Meeting name	Imbalance Settlement Group (ISG)
Date of meeting	24 November 2009
Paper title	Change Proposal Progression
Purpose of paper	For Decision
Synopsis	This paper provides: <ul style="list-style-type: none">• CP1315 for decision;• details of a change to Code of Practice 4 that the ISG is requested to agree to treat as Housekeeping; and• an update on the status of all Open Draft Change Proposals (DCPs) and Change Proposals (CPs).

1.1 CP1315 'Maintenance of Outstation Types as part of Compliance and protocol approval'

1.6 CP1319 'Housekeeping change to Code of Practice 4 to correct a Manifest Error'

Change Proposal – BSCP40/02	CP No: 1319 <i>Version No: v1.0</i> <i>(mandatory by BSCCo)</i>
Title <i>(mandatory by originator)</i> Housekeeping Change to correct a manifest error in Code of Practice 4	
Description of Problem/Issue <i>(mandatory by originator)</i> Code of Practice 4 (CoP4) deals with the testing, commissioning and calibration of Metering Equipment. It specifically references the tests that are required on Meters both before installation and during their in-service lives. Following the November 2009 BSC release, a manifest error in CoP4 has been highlighted which w

Appendix 2 – Current Workaround (between MOAs and DCs) and CP1315 solution

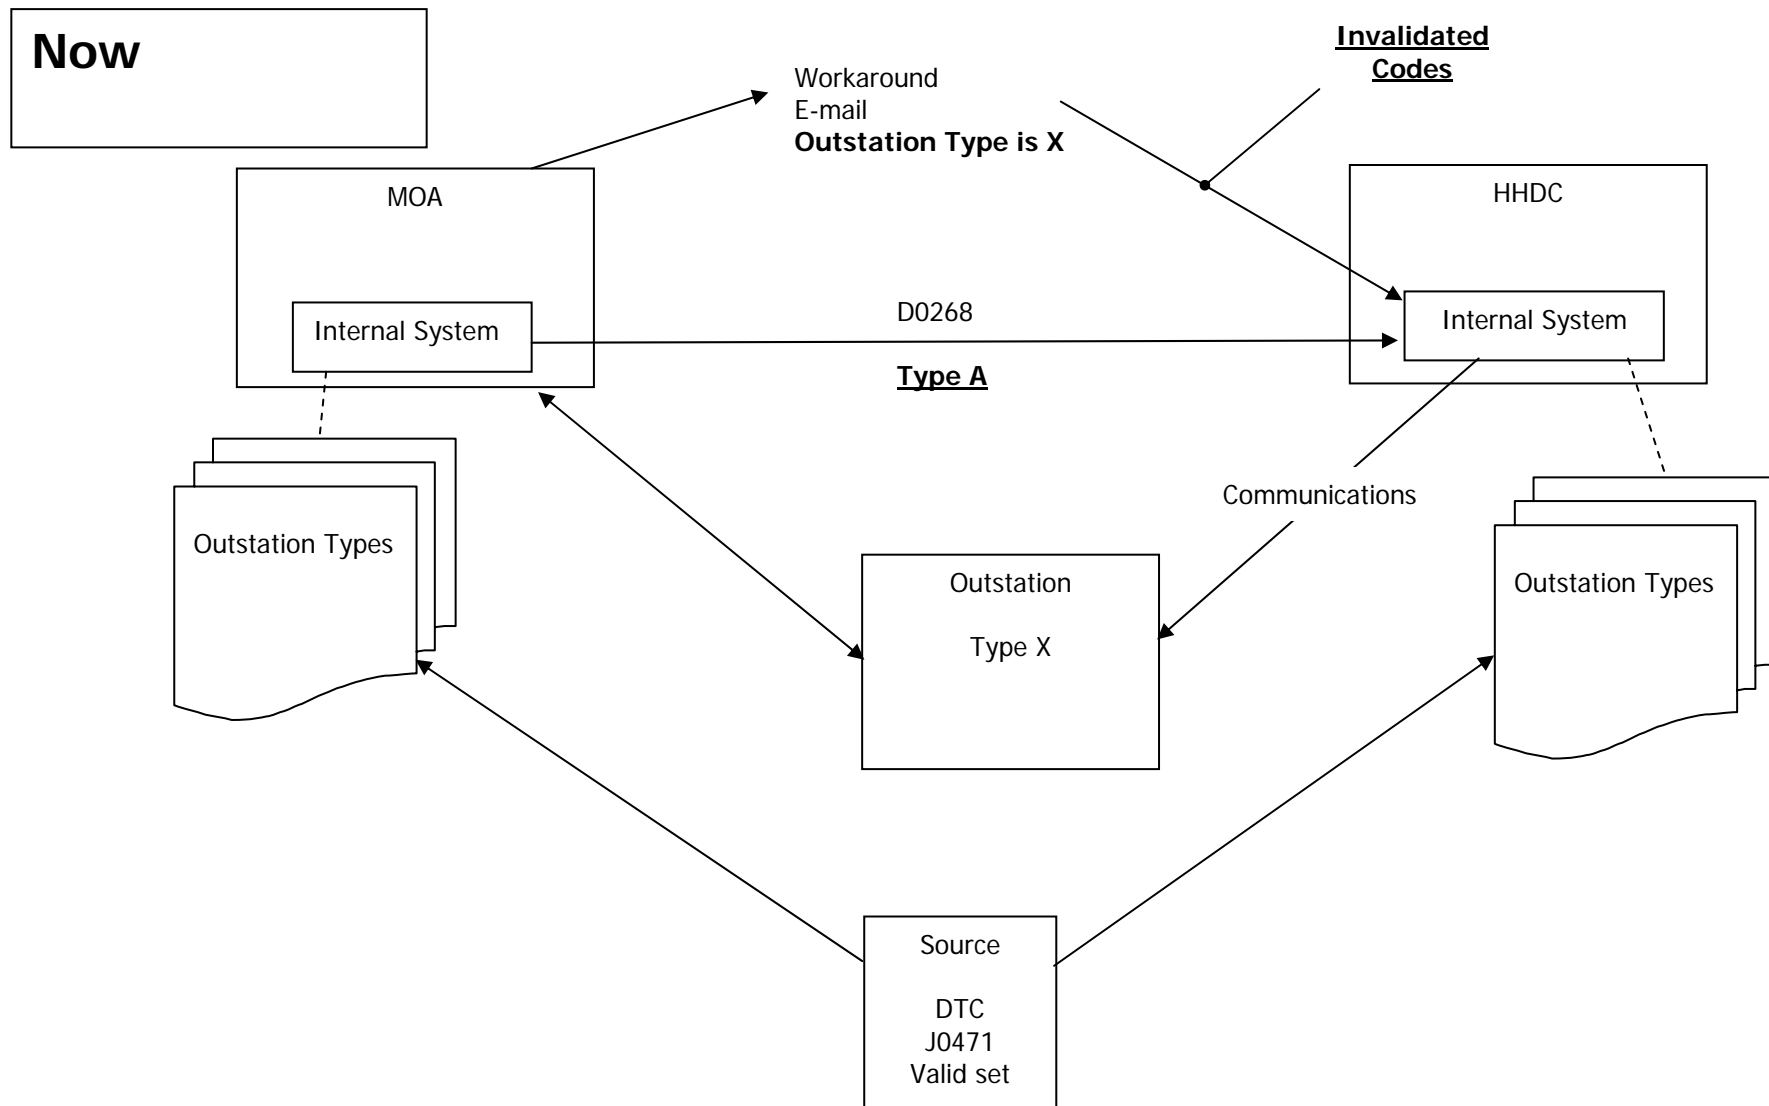
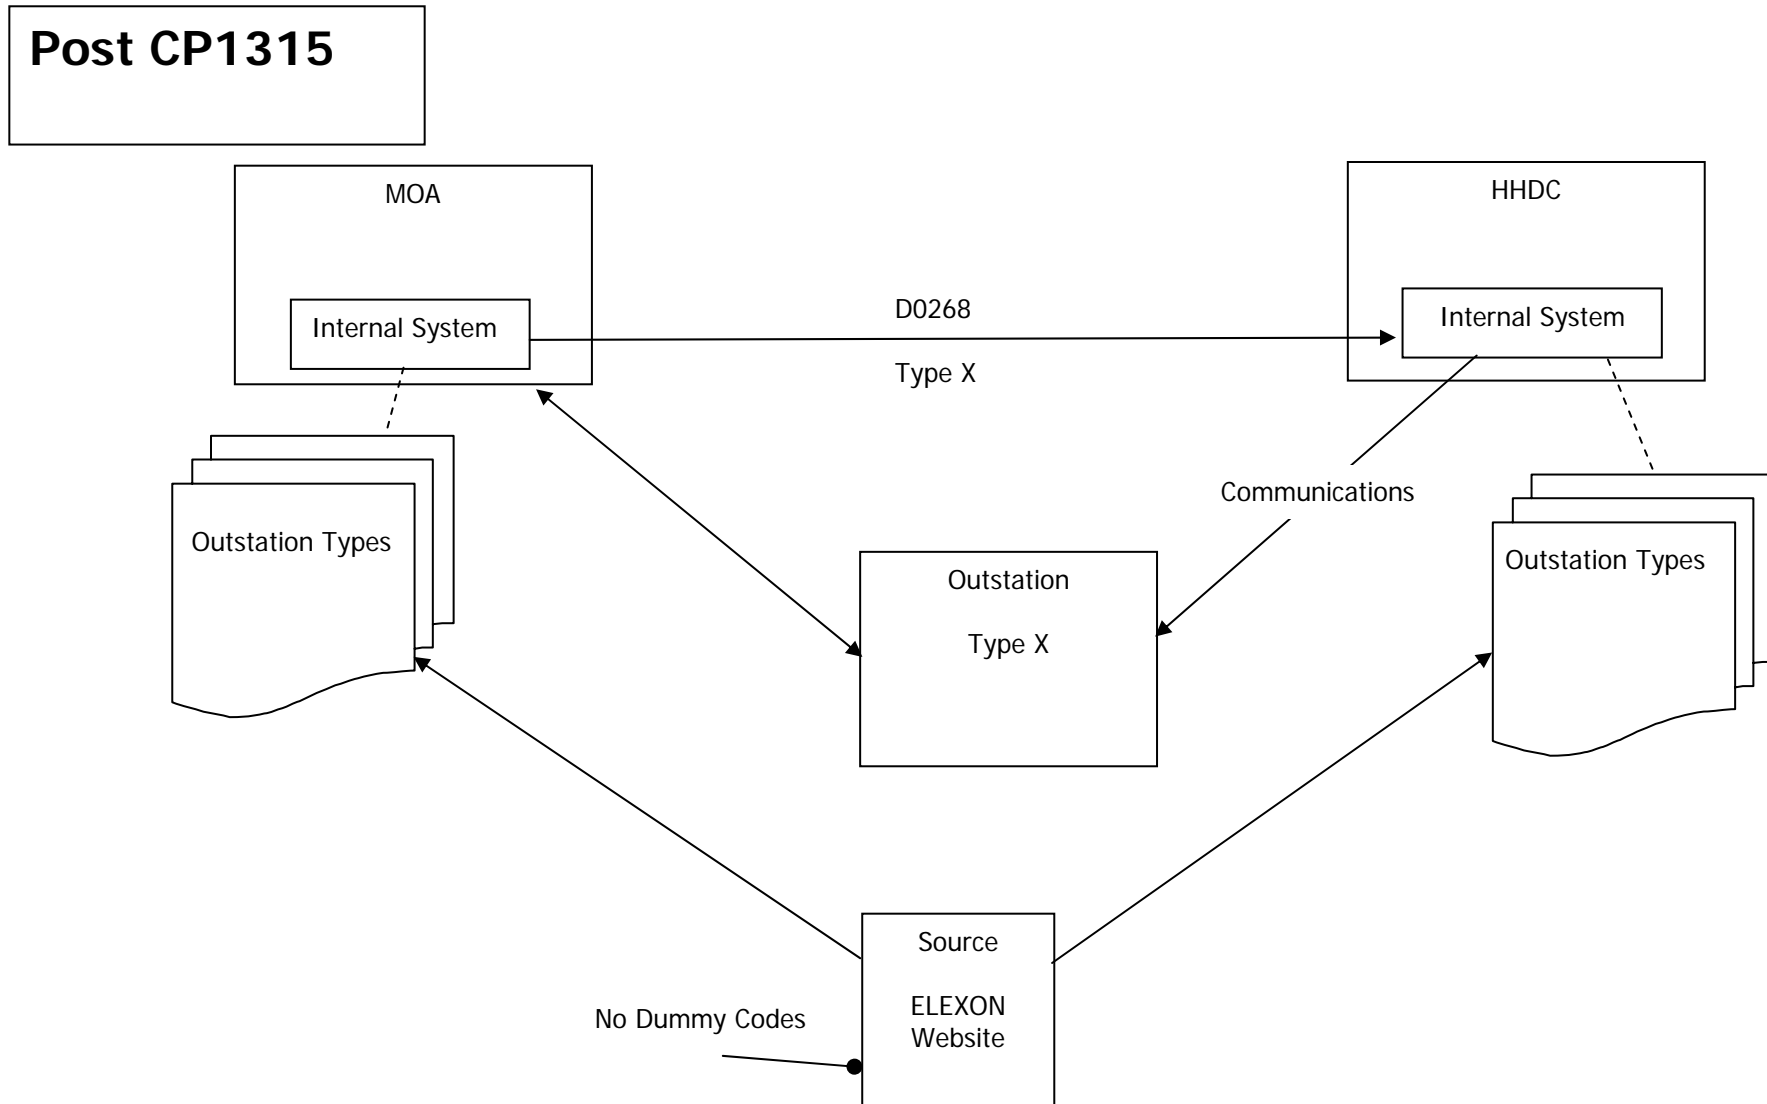
In the following examples, Type X is an Outstation Type that has been approved for use in Settlement, but has no valid code in the DTC. The HHDC may not be able to tell which protocol should be used, therefore preventing them from dialling in to the Outstation.

Current situation - In order to keep the Settlement process working, Supplier Agent hubs are adopting their own workarounds by agreeing new Outstation Type codes between them.

Post CP1315 - Participants will be notified by ELEXON (if they register on myELEXON) to update the valid set of Outstation Types so that HHDCs can dial in to the Outstation more efficiently.

Geometric representation of active and reactive power

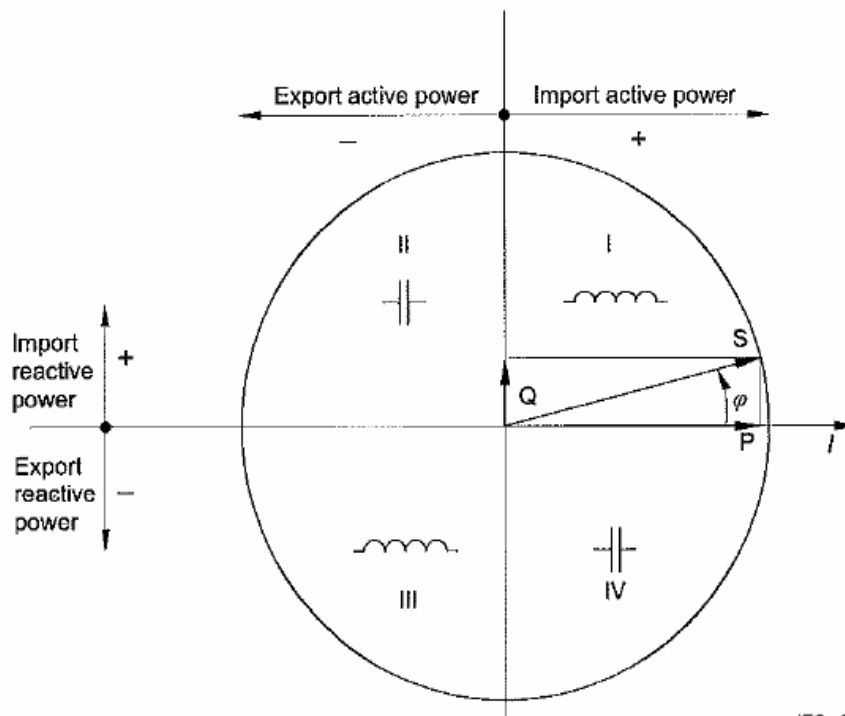
- 1.9 We have raised CP1319 (Attachment C) to correct this manifest error. In drafting CP1319 we noted two further (more minor errors) which we have also included in the CP:
- there are six instances where Meter isn't capitalised in Appendix C; and
 - the symbol used to represent the angle 'φ' is not consistent throughout Appendices B and C.

Proposed Solution <i>(mandatory by originator)</i> CP1319 proposes to: <ul style="list-style-type: none"> • amend the "Test Point" heading in Table B4¹ of Appendix B in CoP4 to read: "Value of Current (I)"; • capitalise the six instances of 'meter' in Appendix C (under Table C1 (a) and under Table C3 (a)) of CoP4; and • correct all instances where an incorrect symbol for 'φ' is used. This will mean changes to Appendix B (Tables B1, B2, B3, B4 and B5) and Appendix C (Tables C1, C1 (a) and C2). We recommend that 'φ' is adopted (rather than 'Ø' which is used in some instances) as 'φ' is used in the diagram following table B1, which is extracted from the British Standards. 	
Justification for Change <i>(mandatory by originator)</i> Correcting this error will provide clear and consistent information to market participants and prevent confusion.	
To which section of the Code does the CP relate, and does the CP facilitate the current provisions of the Code? <i>(mandatory by originator)</i> Yes, this CP will remove a manifest error and several inconsistencies within CoP4, thereby better facilitating the provisions of both Section L and CoP4.
